CITY OF ALBUQUERQUE

PLANNING DEPARTMENT – Development Review Services

**RE: Valle Prado Unit 3, Pad Certification of all lots
Grading and Drainage Plan
Engineer's Stamp Date 3-26-2015 (File: C09D011A)
Certification dated 12-17-2015**

Re: Partial Grading and Drainage Certification, Valle Prado Unit 3
DRB Case No. 1004404, (C09/D011)

CITY OF ALBUQUERQUE PUBLIC WORKS DEPARTMENT	
VALLE PRADO UNIT 3 GRADING AND DRAINAGE PLAN	
Design Review Committee	City Engineer Approval
City Project No. XXXXXX	Zone Map No. C-09-Z
Sheet 1	Of 2

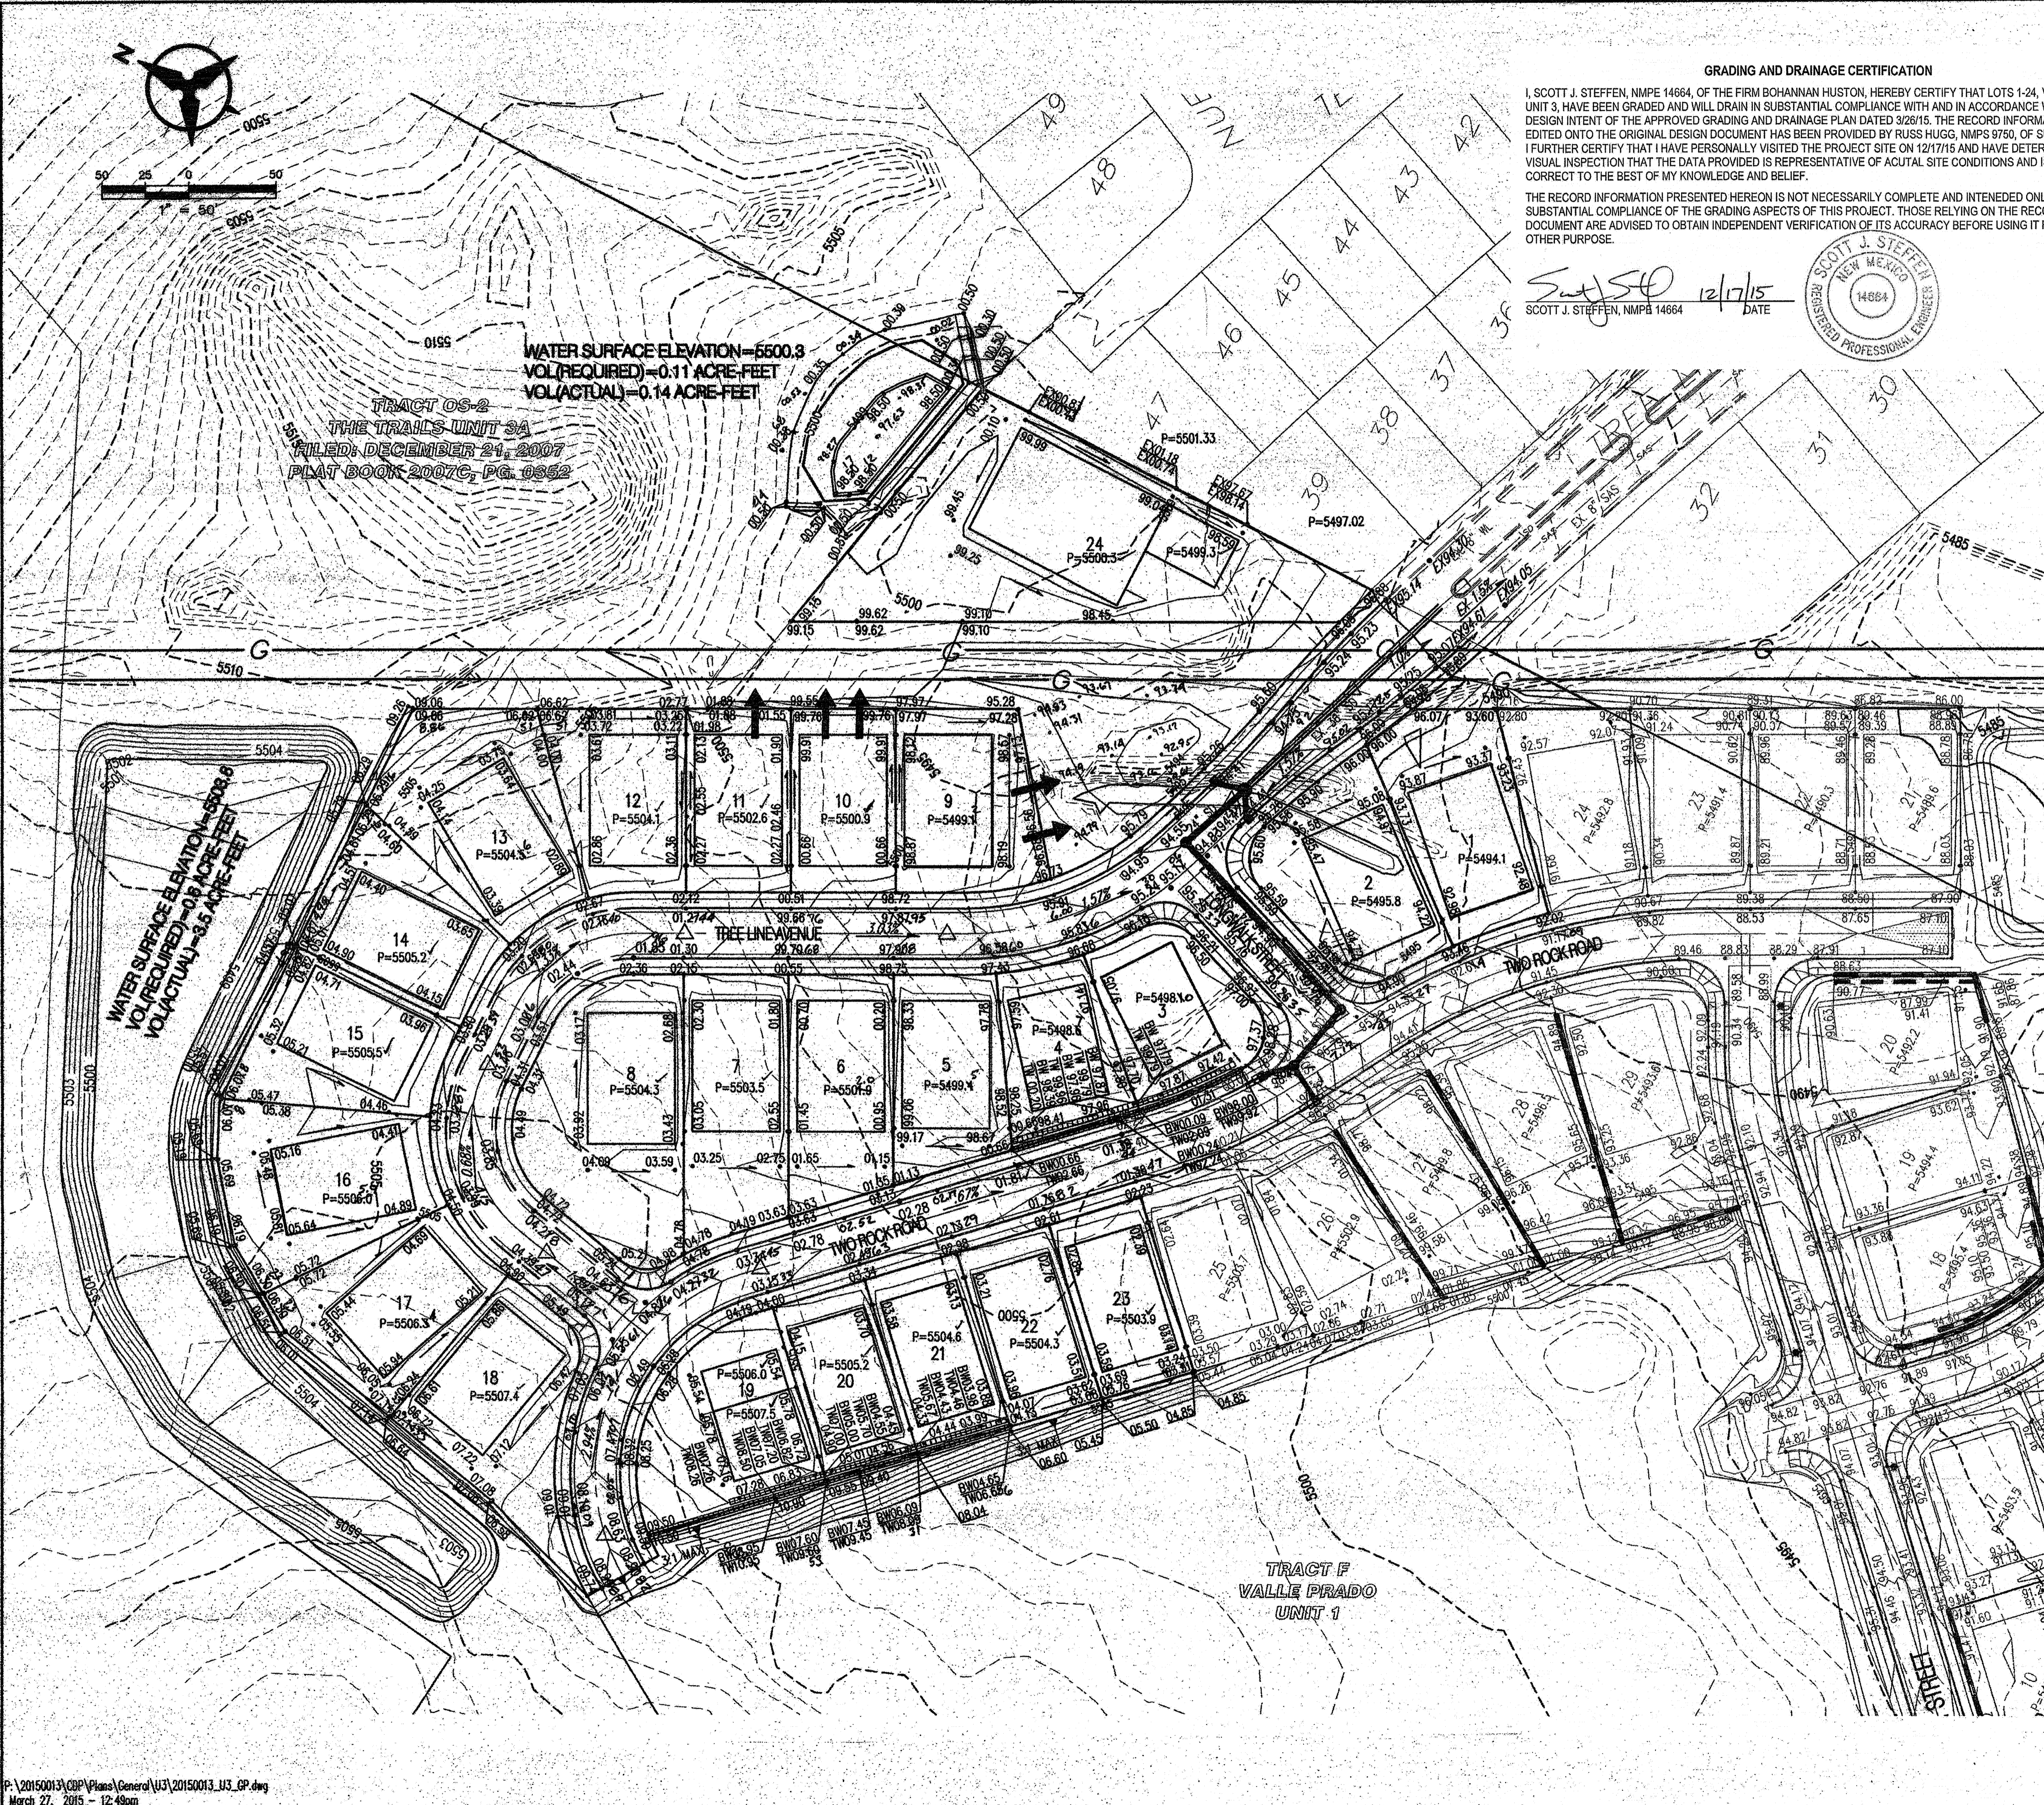
We are submitting a partial grading and drainage certification for Valle Prado Unit 3. The partial certification only includes Valle Prado Unit 3 Lots 1-24. Enclosed for your review is the approved grading and drainage plan dated 3/26/15, with as-built elevations for Unit 3. The Unit 3 lots have been graded, and curb and gutter, pavement and storm drain improvements have been constructed.

After reviewing these as-built elevations and visiting the site on 12/17/15, it is my belief that the Valle Prado Unit 3 subdivision has been graded in substantial compliance with the approved grading and drainage plan.

Based upon the information provided in your Certification received 12-17-2015, the above referenced Certification is acceptable for Building Pad Certification for all lots.

VALLE PRADO UNIT 3 GRADING AND DRAINAGE PLAN

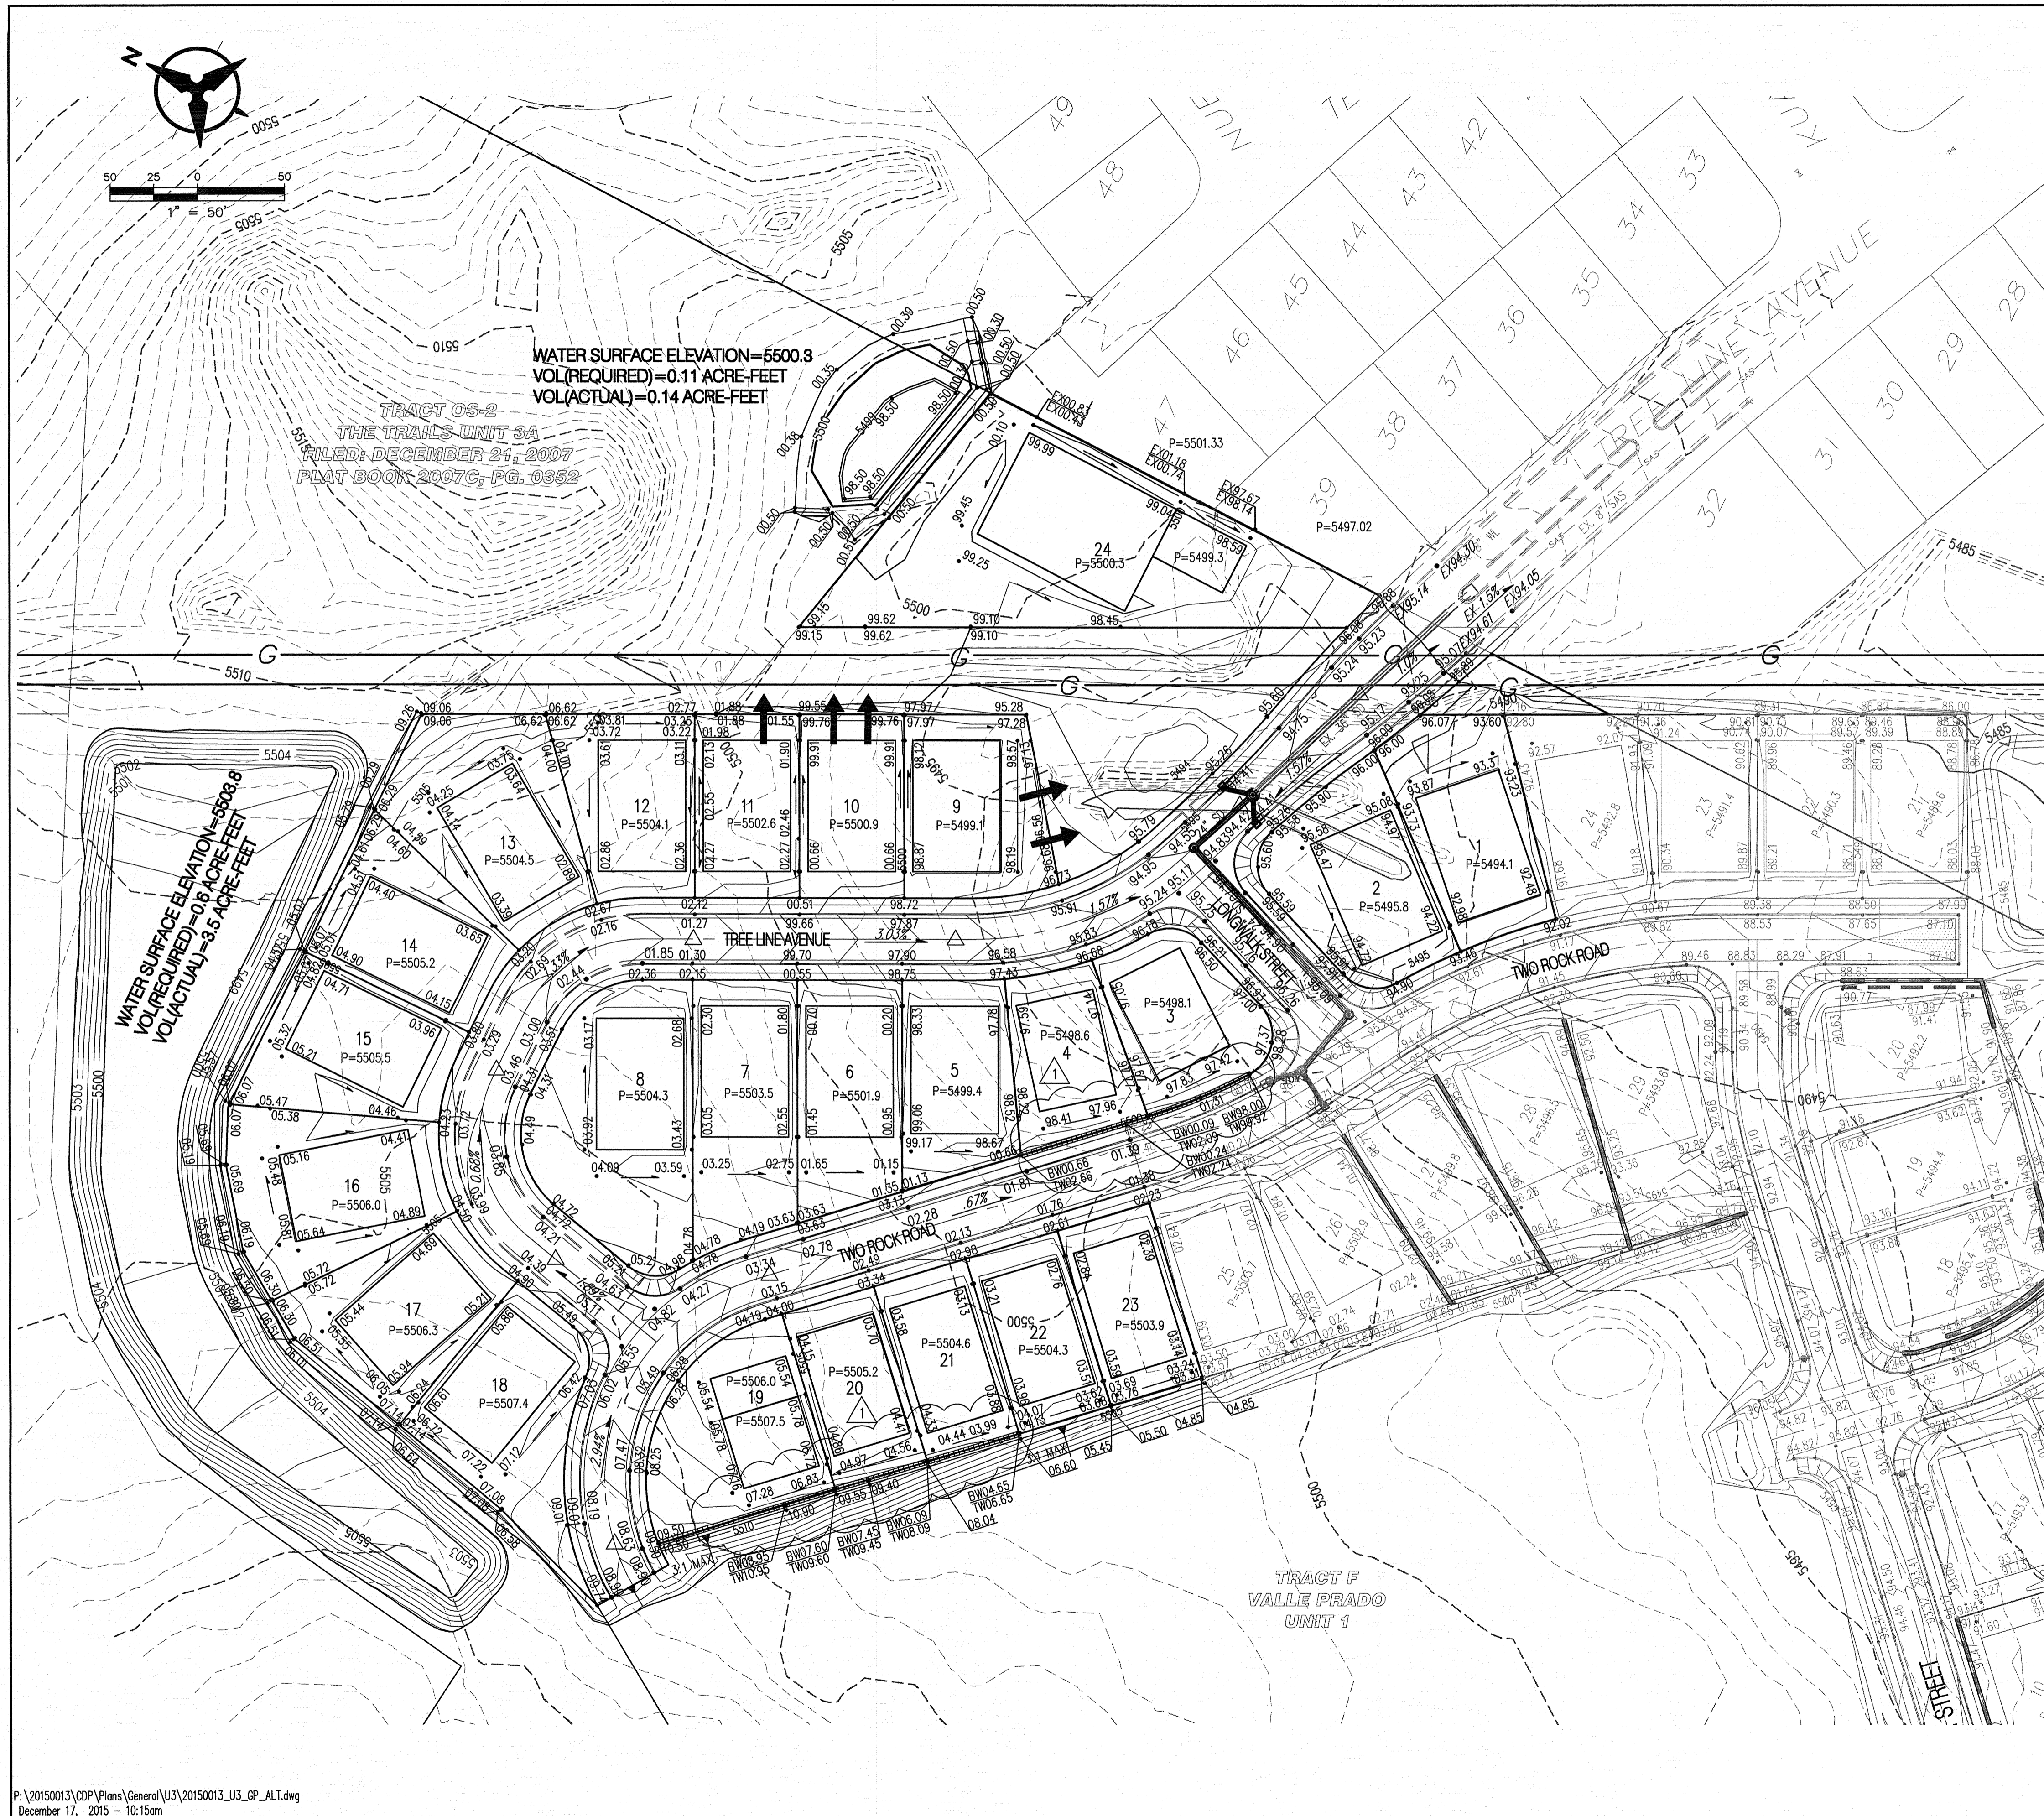
Also enclosed is an alternative grading plan showing a single garden wall on the rear property line for Lots 3-4 and 19-21, a 3:1 maximum slope in the back yard and a shorter pad than on the approved plan. This alternate grading plan is provided for information as to what the lot would look like without the dual garden walls. As such, as-built grades are not provided on the alternative grading plan.

In addition, the homebuilder may choose to move the 4 foot split into a single retaining wall at the lower wall location thereby eliminating the 2 foot split on the upper wall, which would allow for a taller privacy wall on the property line. If the homebuilder chooses to do so, they would be responsible for securing a wall permit to construct the lower wall as a retaining wall.
